## TC 10 Request for Information

Yavapai- Apache Nation

001

**Title:** 1st RFI for contractors

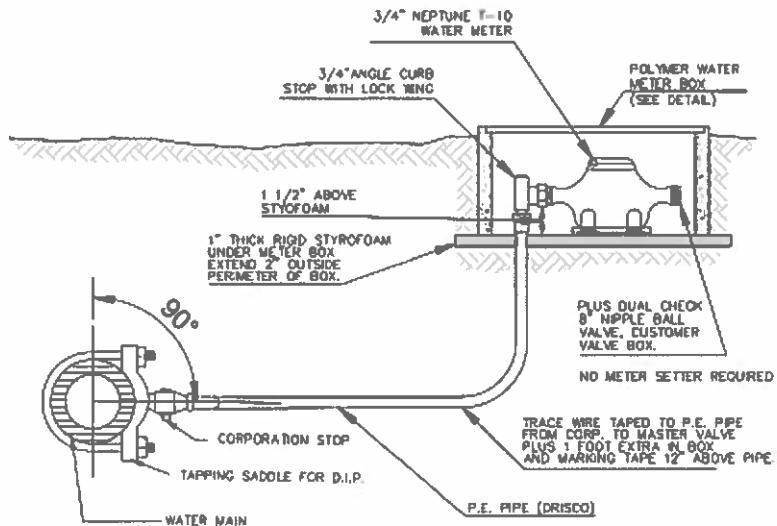
Please Review Email From M&G Dated 12/18/2025  
1) PLEASE Review/Revised KEYNOTE [1]  
DETAIL 324CV-1 C-33

2) Please CLARIFY KEYNOTE [2] DETAIL 341 C-31

1) KEY NOTE [1] DETAIL 324CV-1 ON C-33  
DELETE FROM SERVICES

2) WATER MAIN IS C 900  
SERVICE LINES ARE 1" PER TO HOME  
3/4 STUBS FOR LAND SLASH

**3/4" AND 1" WATER SERVICE CONNECTION**

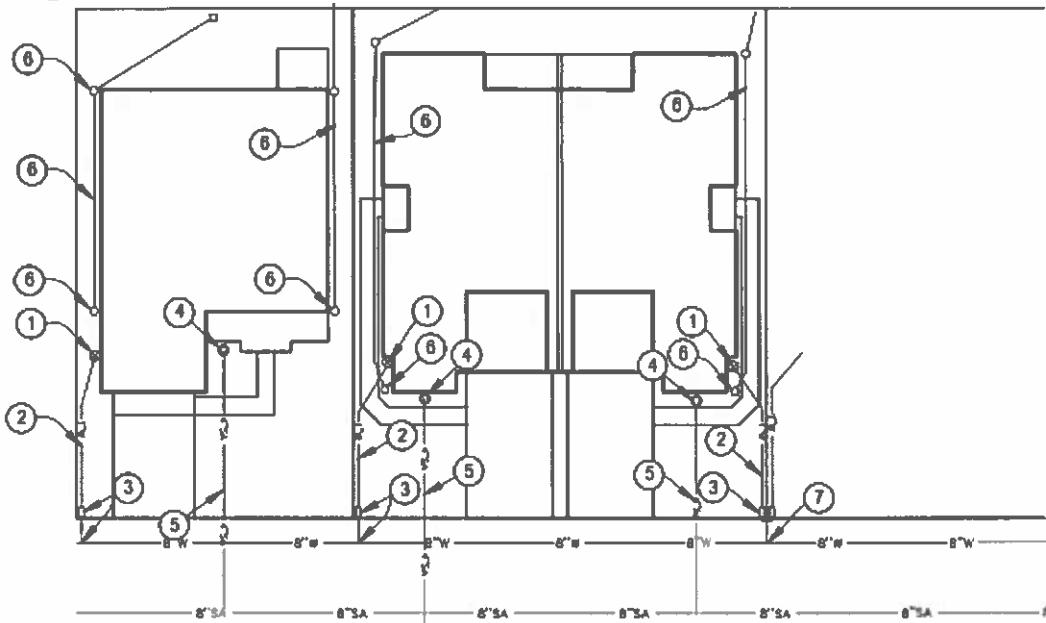
The water service details being called out for the TC10 project are not consistent with what we normally see for a domestic water service nor do they match what was required on TC8 and TC9 water services. Note 1 calls for a backflow prevention device per detail 324CV-1. This is not necessary for a domestic water service and is not what was required/installed on TC8 or TC9 (TC8 and TC9 had pressure reducing valves and check valves in each water service). Note 2 calls for 1" c900 which does not exist. 1" pipe is also probably overkill. Most domestic water services are  $\frac{3}{4}$ " unless it's a very large house. I would consider reaching out to Sefton to provide an updated water service detail that is consistent with what was required on TC8 and TC9. Or release an addendum yourselves with the water service details used on TC8/TC9. The way the plans are now I feel that the pricing is going to vary drastically from contractor to contractor and you are not going to get what you actually need. I added picture below of the water service detail used on TC8/TC9. Please call with any questions or concerns.

**Response:** The water main is to be C900.

The service lines are to be 1" pex to the house, with a 3/4 stub out for landscaping.

The Pressure reducer will be installed inside the home by the plumbing contractor and not part of the civil plans.
